**SUPPLEMENTAL/BID BULLETIN NO. 1
For LBP-ICTBAC- ITB-GS-20250313-01**

PROJECT: Supply and Delivery of Automated Teller Machine inclusive of One (1) Year Warranty, Terminal Integration Certification, Four (4) years Maintenance Support Services and Spare Parts

DATE: 21 April 2025

This Supplemental/Bid Bulletin is issued to modify, amend and/or clarify certain items in the Bid Documents. This shall form an integral part of the Bid Documents.

Revised Annex D-30

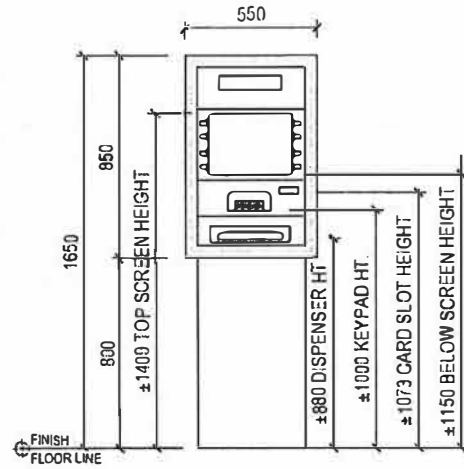
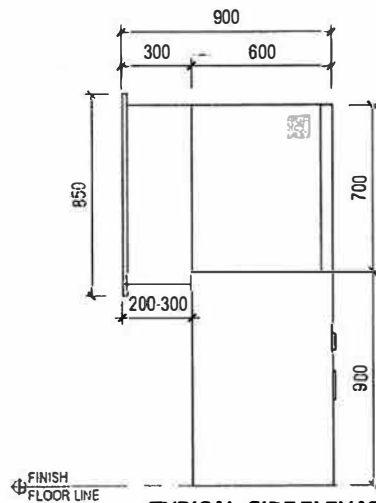
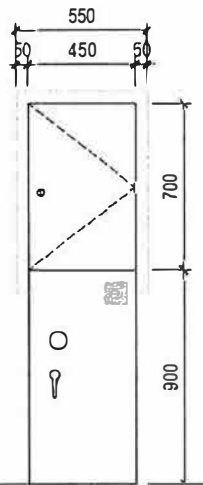
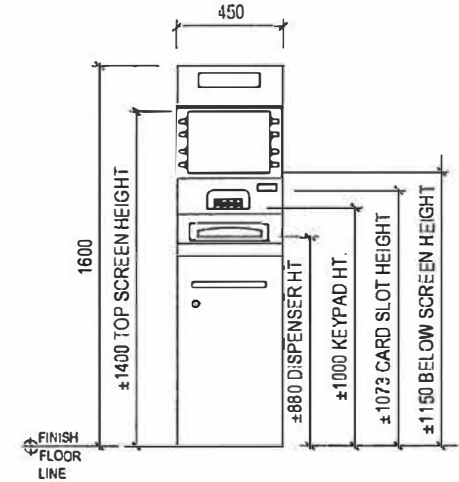
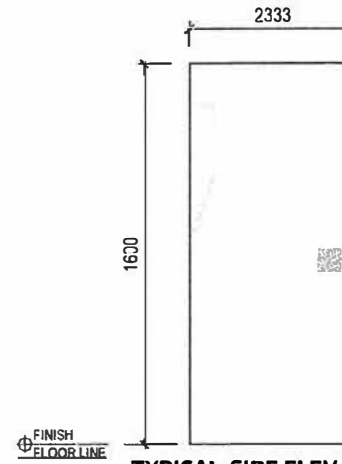
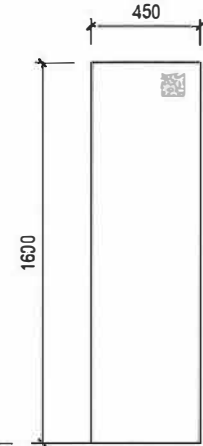
Annex D-9 page 87	V.1	<p>SHALL COMPLY WITH THE BANK'S PRESCRIBED ATM HEIGHT AND CLEARANCE REQUIREMENTS</p> <p>DN new TTW ATM portfolio (can only accommodate a maximum of 200mm wall thickness.</p> <p>DN requests for a maximum of 200mm wall thickness for TTW ATMs.</p>	<p>We have issued an updated provision in the TOR (Annex D-30 for item V of the Hardware Features for the prescribed ATM height and clearance requirements).</p>
		<p>DN would like to clarify if the vendors MUST have a 100% headcount of its Field Engineers</p> <p>If the bank will allow the vendors to have a mix of inhouse and outsourced field engineers, DN would like to know how the bank intent to monitor if all the vendor's Field Engineers that services LBP machines are inhouse personnel?</p>	<p>As mentioned in the TOR (item C.2 of the Maintenance Services Coverage), the Service Engineer should be an employee of the Vendor and not outsourced from a Third-party Service Provider.</p> <p>We will require a notarized certification from the vendor on this requirement</p>

V. ATM HEIGHT REQUIREMENT	V.1	SHALL COMPLY WITH THE BANK'S PRESCRIBED ATM HEIGHT AND CLEARANCE REQUIREMENTS (FOR DISPENSER, KEYPAD AND MONITOR) (SEE ANNEX D-30), SUBJECT TO THE ACTUAL INSPECTION AND EVALUATION BY LBP-PMED
